## **Statement of Compliance Access for People with a Disability**

### **Proposed Residential Development**

**27 Addison St SHellharbour**

**Report Type:** Statement of Compliance - BCA Access Provisions  
**Development:** 27 Addison St Shellharbour

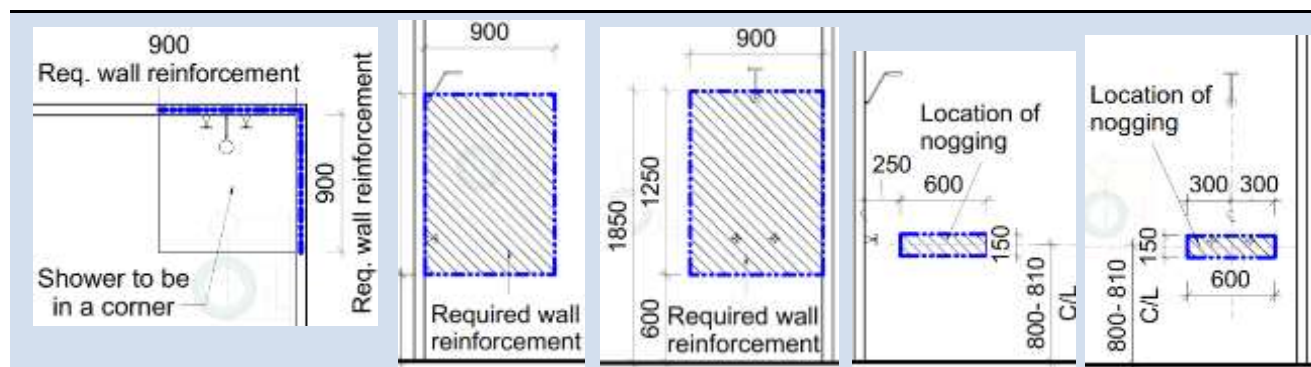
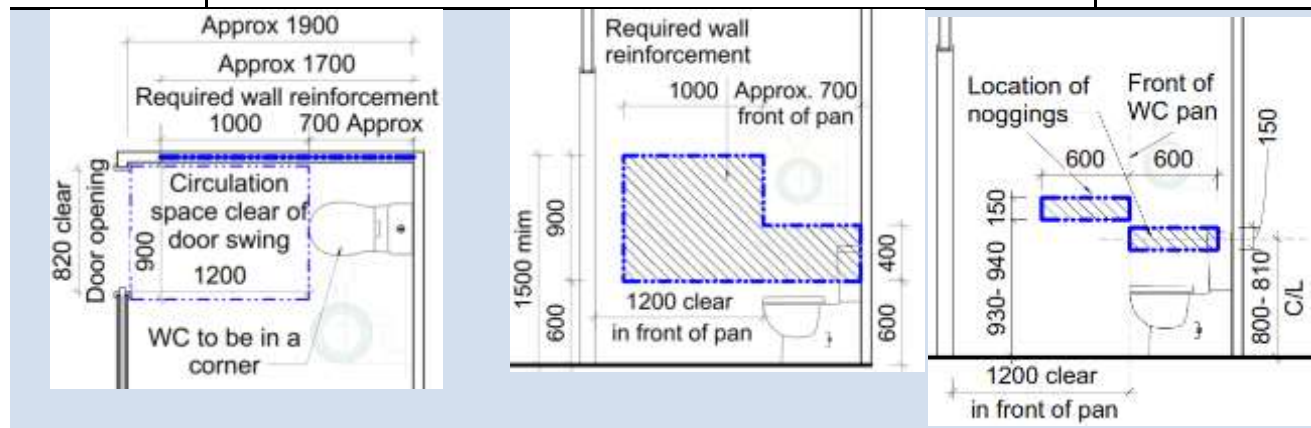
Total number of residential units in the development = 20% of 9 = 1.8 = **2** required Livable units.

Since **2** of the units (**203 & 303**) already comply with the Adaptable unit requirements, these units are also capable of satisfying the intent of Silver level of Livable Housing Guidelines as noted in the table below.
